Piper Aircraft, Inc.  
2926 Piper Drive  
Vero Beach, FL, U.S.A. 32960

# SERVICE NO. 540B BULLETIN

Date: February 9, 2021

**INSPECTION AND REINFORCEMENT OF  
STABILATOR TIP TUBE AND WEIGHT ASSEMBLY**

**Figure 1**  
Top View and Side View of Tube and Weight Assembly

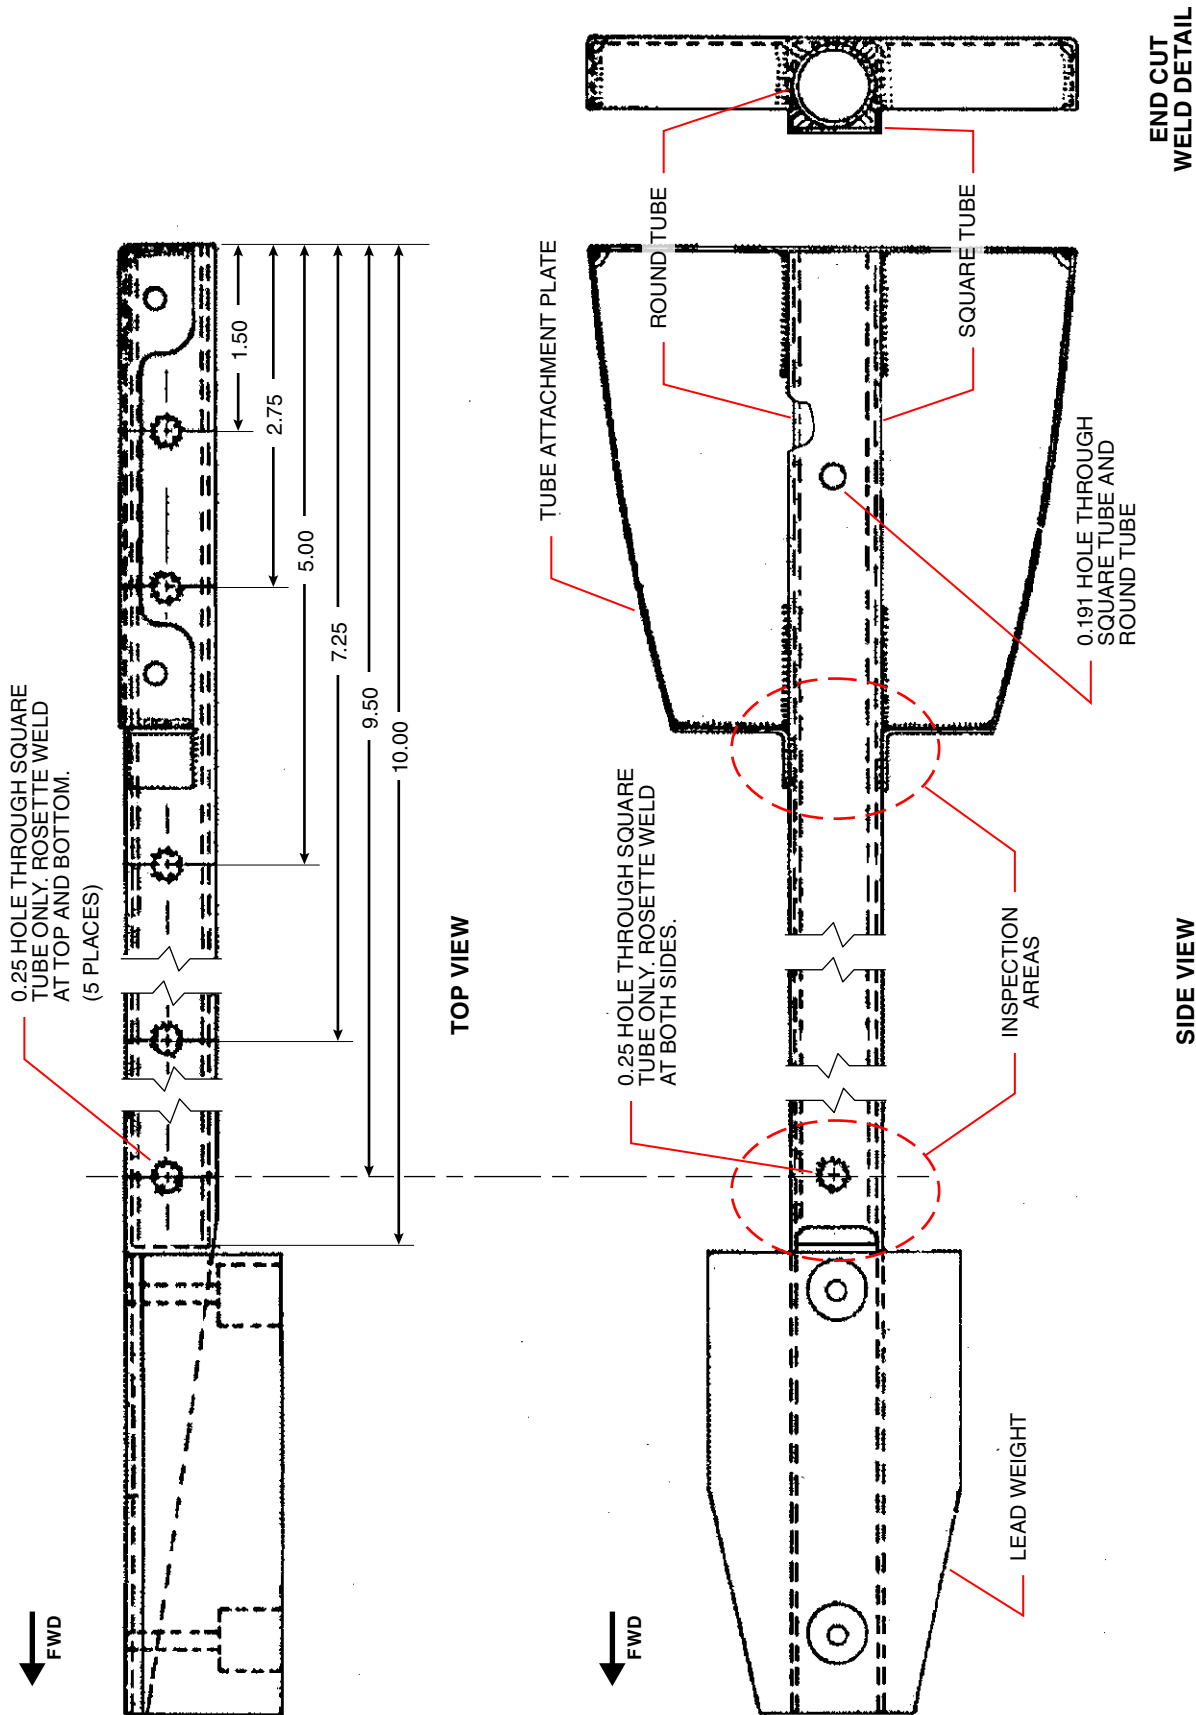
3. RC – For serial numbers (S/Ns) 27-7654001 through 27-7954035 if Stabilator Balance Weight Replacement Kit, Piper P/N 763-987, **is not installed**: examine the inspection areas identified in Figure 1. Perform the inspection using a 10X magnifier, a mirror, and a suitable light source or other equipment capable of providing equal or better resolution.

- **If cracks are found**, repair the tube and weight assembly as described in Part II, prior to next flight.
  - **If no cracks are found**, then proceed to Part III.

**NOTE:** Figure 1 shows a stabilator tip tube and weight assembly after repair.

RC – These repair instructions are applicable only to S/Ns 27-7654001 through 27-7954035 without Kit P/N 763-987 installed. Refer to Figure 1.

1. RC – Remove the stabilator tip tube and weight assembly from the aircraft.
2. RC – Modify both tube and weight assemblies as follows:
  - a. Remove the tube and weight assemblies from both stabilators. Retain screws, washers and nuts for reinstallation; replace any hardware on condition.

- b. Cut or drill a hole in the end of the tube attachment plate to allow a 5/8 inch diameter tube to be inserted into the square tube.
  - c. Locate and drill twelve (12) 0.250 holes in the square tube as shown in Figure 1.

- d. Insert a 10-inch length of round steel tube (5/8 x 0.058 Type 4130 Cond. N) into the square tube and rosette weld the tubes together at the twelve (12) 0.250 holes.

- e. Weld shut the area around the hole in the attachment plate and the tubes.
  - f. Weld shut any cracks that were discovered when inspecting the square tube.

- g. Drill a 0.191 hole through the round tube using existing hole in square tube as a guide.
- h. Clean, prime and paint tube and weight assembly.
- i. Reinstall the tube and weight assembly to the stabilator using existing attachment hardware.

**Figure 2**  
Side View of Tube and Weight Assembly

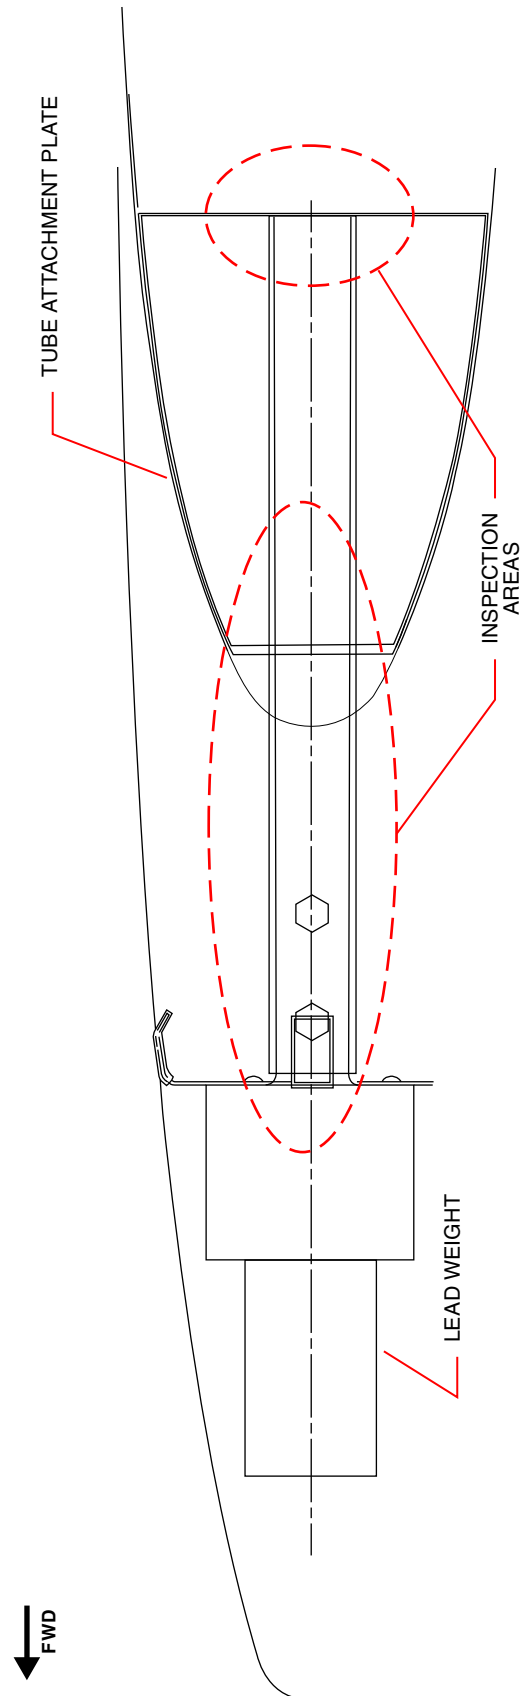
4. RC – For S/Ns 27-7954036 through 27-7954121; and for S/Ns 27-7654001 through 27-7954035 if Stabilator Balance Weight Replacement Kit, P/N 763-987, is installed: examine the inspection areas identified in Figure 2. Perform the inspection using a 10X magnifier, a mirror, and a suitable light source or other equipment capable of providing equal or better resolution.
  - **If cracks are found**, then repair is necessary prior to next flight. Contact Piper Customer Service for assistance at (+1) 772-299-2141 or CustomerService@piper.com. Piper’s normal business hours are Monday through Friday, 7:30 a.m. to 4:30 p.m. (Eastern).
  - **If no cracks are found**, then proceed to Part III.
